Dear Planning Inspectorate,

It has recently come to my attention that the applicant's photo montages at Lodge Lane North and South are flawed. I have lived on my farm [REDACTED] for 50 years, and family have owned Necton Farm since 1947 so we are all extremely familiar with the lay of the land. The applicant has said that they don't know whether the the rise in landform shown as being to the fore of the onshore project substation actually occurs or not, and it cannot be determined from the baseline photograph, as the mature woodland associated with Lodge Farm screens this portion of the view. Using Google Earth Pro, ground levels through Lodge Farm trees shows that the land continues to gently fall to the west, away from the lane, as it does all the the way along the lane, up to Lodge Farm. I have also walked the area and I can confirm this, with no concealed ridgeline. I disagree with the applicants opinion, that the more critical point in terms of screening is the extent to which the landform falls away to the south. I agree the land falls approximately 5m from Lodge Farm to the viewpoint, but the land continues to rise a further 3m beyond Lodge Farm, to the converter halls. Wit

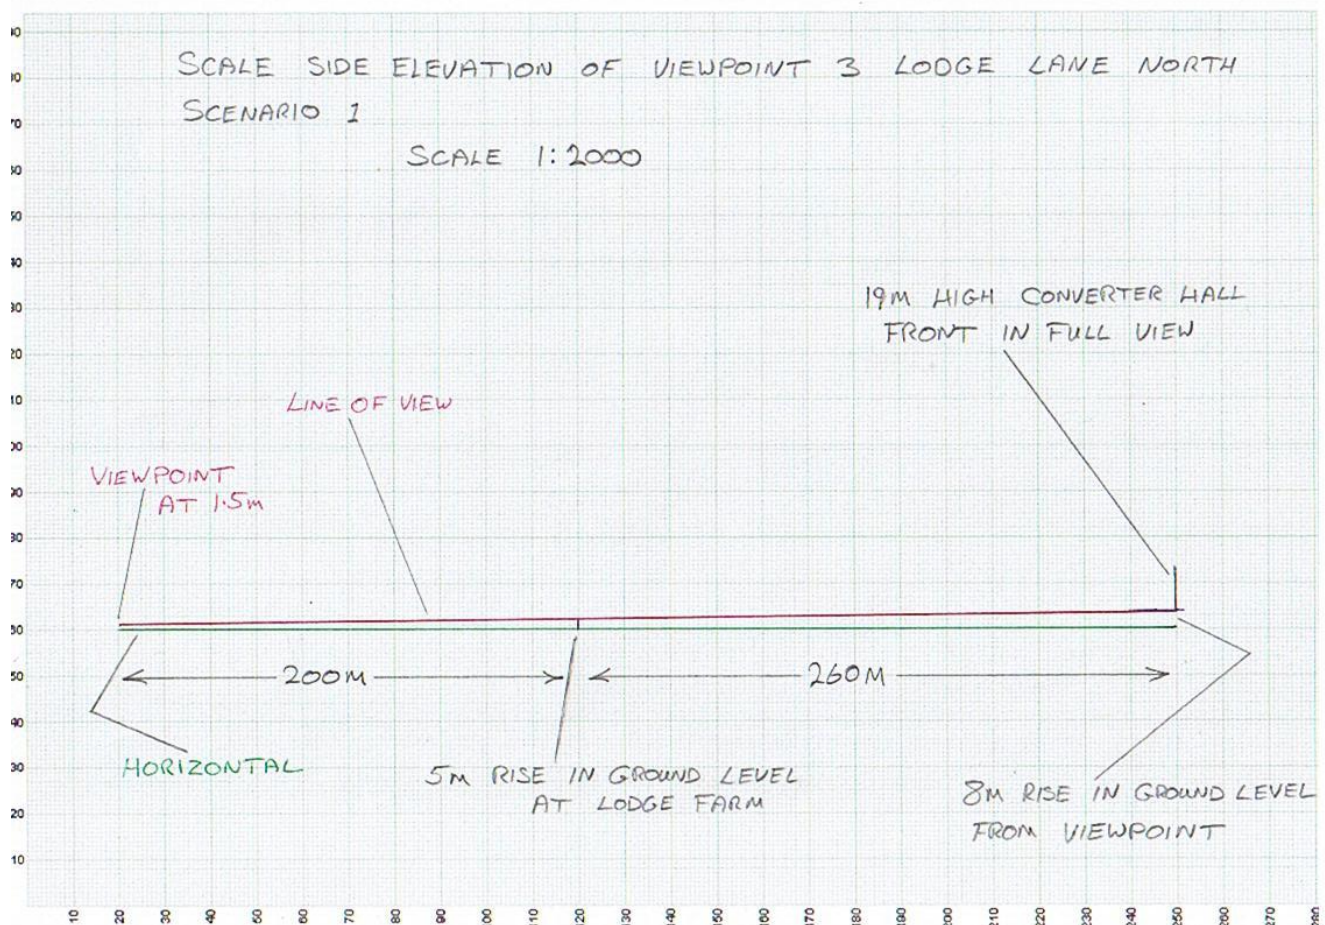
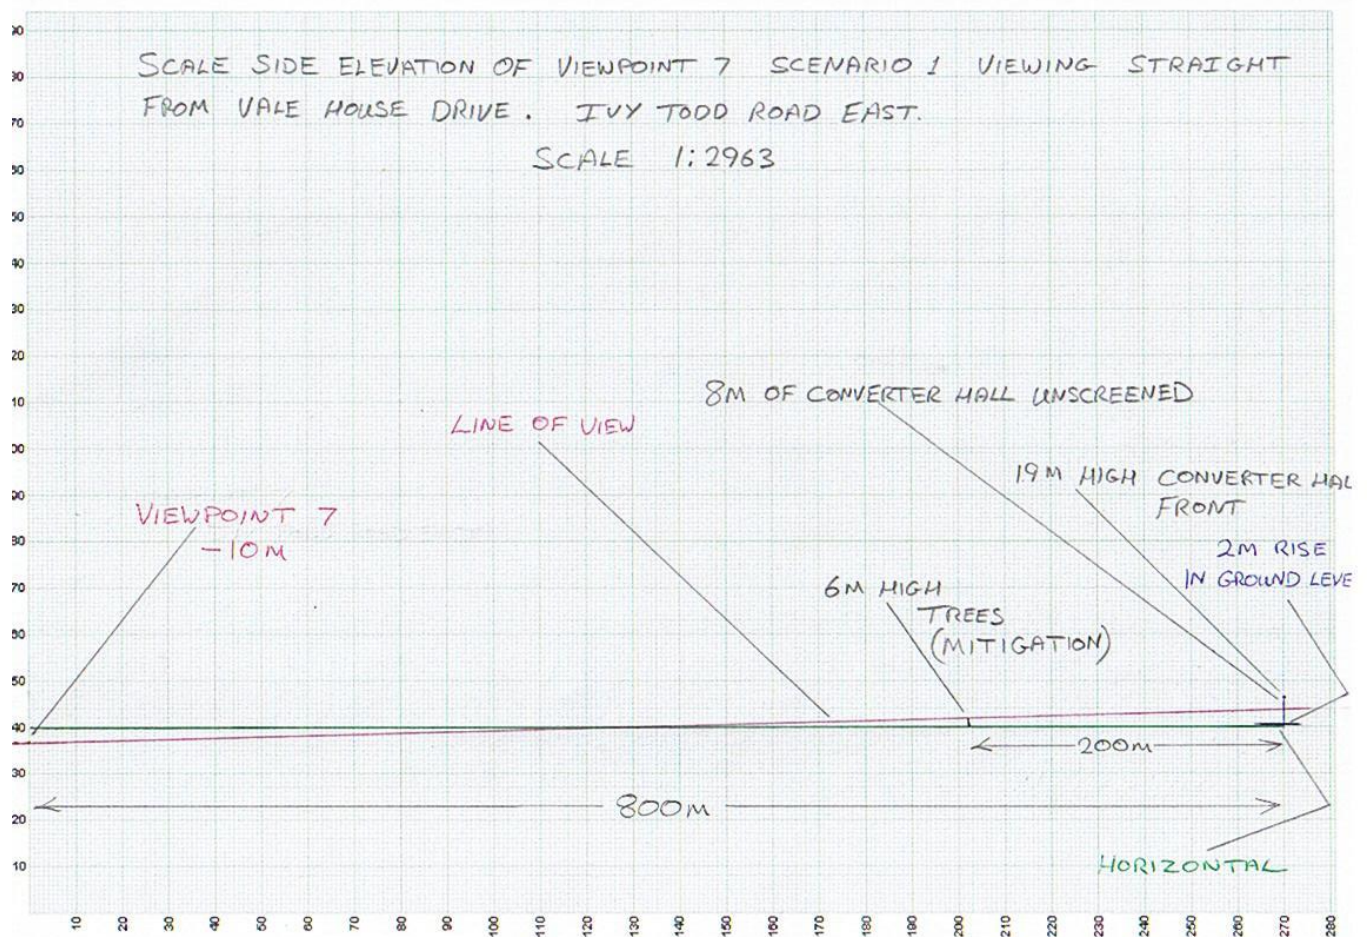
In the applicant's response to viewpoint 7 Ivy Todd Road East scenario 1, they seem to have ignored the effect of the distance between the viewpoint and the mitigating trees. I agree with the ground levels mentioned, and the viewpoint is 10m lower than the ground level at the mitigating tree planting. Working with a viewline from viewpoint 7 to the centre of the Boreas site, the relevant dimensions are: The distance from viewpoint 7 to the mitigating trees is 600m. The ground level at the trees is 10m higher than the viewpoint. The trees are assumed 6m (mid way of the applicants estimation), and they are 200m from the converter halls, at this point (they are set at an angle). The ground level of the converter halls is 2m higher than the mitigating trees (ground levels from Google Earth Pro). With these dimensions it has again been possible to draft a scale diagram, to demonstrate the achieved mitigation. The result shows an 11m mitigation and 8m unmitigated, not the full mitigation shown in the photo montage. I have used Google Earth Pro for ground levels in both cases, and in both cases this can be verified by eye, the reason I noticed a problem.

The only explanation for these discrepancies in my opinion is, the OS 5m DTM software used by the applicant has an accuracy of $\pm 2.5\text{m}$ rural, and less accurate where trees and buildings cover the terrain. The aforementioned mature woodland associated with Lodge Farm, has the capacity to cause a ridgeline to be seen, great enough to cause the effect we are seeing at viewpoints 2 and 3 Lodge Lane, and the $\pm 2.5\text{m}$ accuracy over the distance involved with viewpoint 7 could be enough to produce the photo montage in question.

On 23rd January 2020 I attended an accompanied site visit with the Boreas Planning Inspectors. I was able to show them the errors produced by the applicant's software and demonstrate at the sites that there was no ridges where they are shown on the photomontages at Viewpoint 7. Unfortunately Viewpoint 3 was not included in this Accompanied Inspection. This is because the applicant has been misleading residents during both consultations to believe that they were concerned by private individual's views, whereas at the inspection they gave me the impression that they are really only concerned with public viewpoints. If we had known how things stood we would have requested a site visit to Lodge Lane. We would also have asked for a visit to Ivy Todd Road and Chapel Lane, where the substations would be seen from the public highway.
